Facility: Albert Oakland Park & Pool

Address: 1900 Blue Ridge Blvd. Date of Survey: 06/06/10

Photo 3

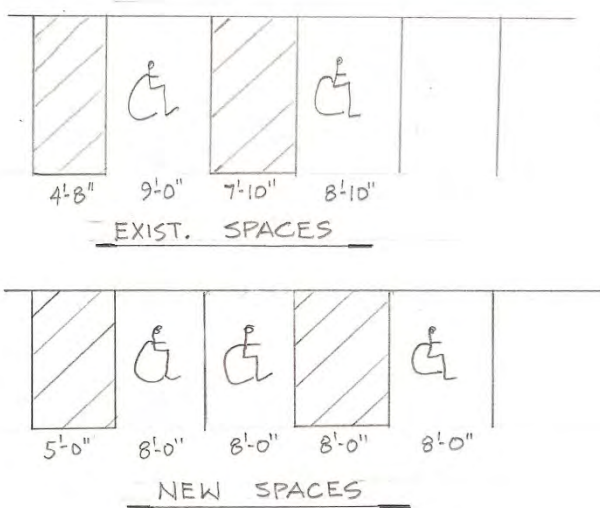
- Refer to site plan included with this report: (7) There are two existing ADA spaces in this parking area, but three are required due to total lot count of 56. Slopes of spaces are up to 3% and cross-slopes are up to 4.3%. Modify the layout of the existing spaces by adding one new parking space and properly sizing the access aisles as shown in the sketch below. Repave for proper slopes, restripe, relocate the existing van-access parking sign, add one additional ADA parking sign mounted at 72" above grade and patch/smooth the gap between the asphalt parking and the concrete walk (see photo 3 below).

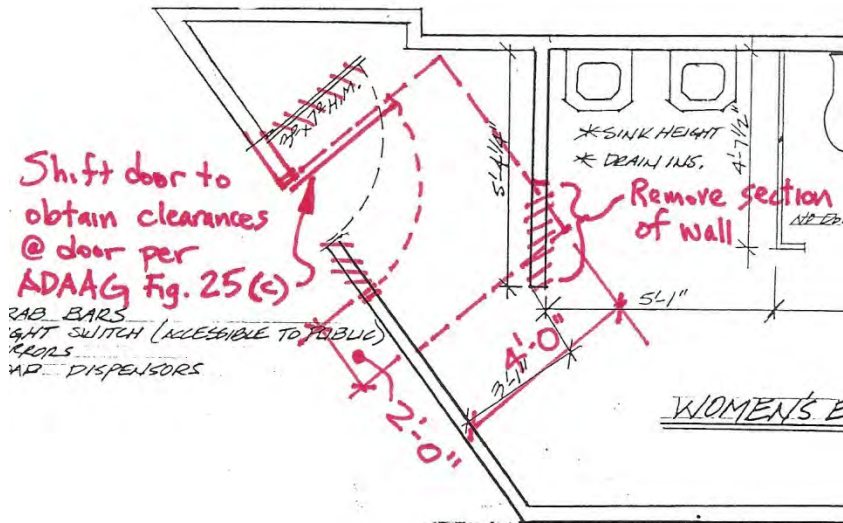
- Refer to site plan included with this report: (T) Public Women's Restroom @ Pool Facility: Existing entry door does not meet clearance requirements of ADAAG 4.13.6 and Fig. 25 (c) – modify entry area as shown in restroom sketch on next page. Existing toilet is 17" from side wall to center of fixture which is now acceptable per the new 2010 ADA Standards for Accessible Design, but the seat height is low (14.5" high) - install a toilet seat extender to raise seat to be 17" – 19" a.f.f. Existing lavatory does not meet ADAAG 4.19 requirements for knee clearance below the lavatory – raise lavatory so that the top surface is 34" a.f.f. Install braille/tactile ADA restroom sign on latch side of entrance door at 60" above floor to centerline of sign. **Estimated Cost: \$1,336.00**

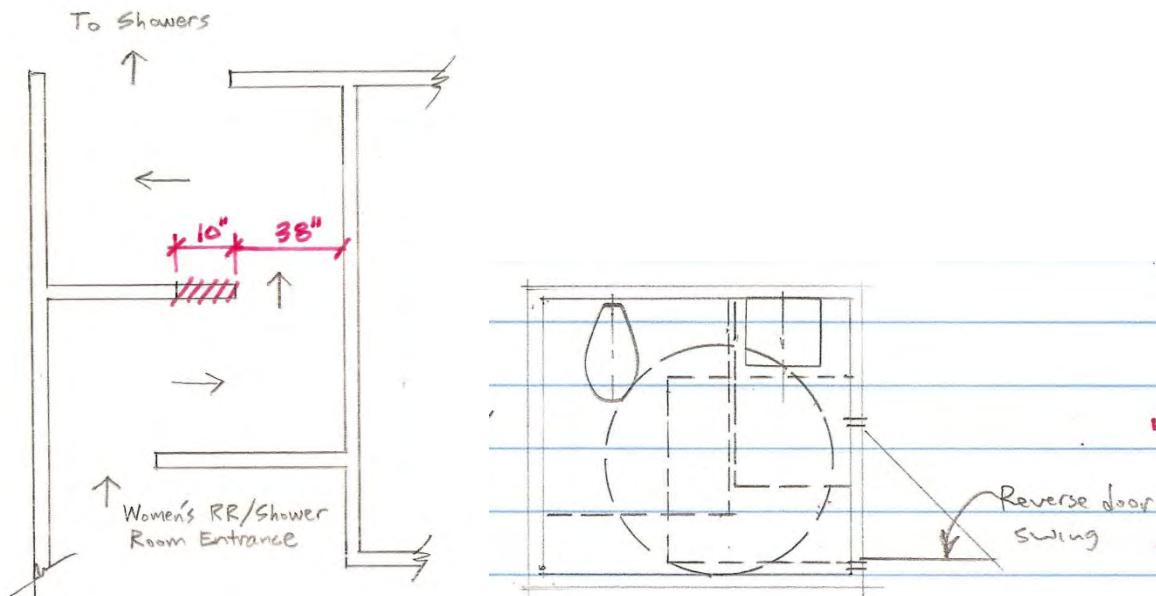
- Refer to site plan included with this report: (V) Women's Pool Restroom/Shower Room: Remove a min. 10" section of c.m.u. privacy wall to allow for proper wheelchair maneuvering space at entry area (see sketch below). Existing toilet is 19" from side wall to center of fixture which is non-compliant (ADAAG requires 18") – shift side stall divider panel 1" into the ADA stall to get to 18". The side grab bar needs to be moved so that it is 12" off of the rear wall and a rear grab bar needs to be installed (36" long min. at 6" off of side wall and at 33" – 36" a.f.f.). Additionally, because this restroom has a total of six toilet stalls, one of the existing toilet stalls needs to be reconfigured to be a 36" wide accessible stall meeting ADAAG 4.22.4. Existing lavatory does not meet ADAAG 4.19 requirements for knee clearance below the lavatory – raise one lavatory so that the top surface is 34" a.f.f. and insulate the pipes beneath. Width of the ADA transfer shower is 37.5" which is 1.5" wider than transfer shower required by ADAAG Fig. 35 (a) – fur out seat wall 1.5" to obtain required width of 36". Lower existing mirror such that the max. height from floor to the lowest reflective surface of the mirror is 40". Add an accessible locker key handle to at least one locker and install braille/tactile ADA restroom sign on latch side of entrance door at 60" above floor to centerline of sign.

- Refer to site plan included with this report: (W) Family Pool Restroom/Shower Room: In order to obtain proper wheelchair maneuvering clearances at the toilet room door, replace frame and use same door so that the door swings out (hinged on same jamb side as previous – see sketch above). Move side grab bar so that it is 12" from the rear wall and replace the rear 24" long grab bar with a min. 36" long grab bar mounted at 33" – 36" a.f.f. Existing lavatory does not meet ADAAG 4.19 requirements for knee clearance below the lavatory – raise one lavatory so that the top surface is 34" a.f.f. and insulate the pipes beneath. Add an
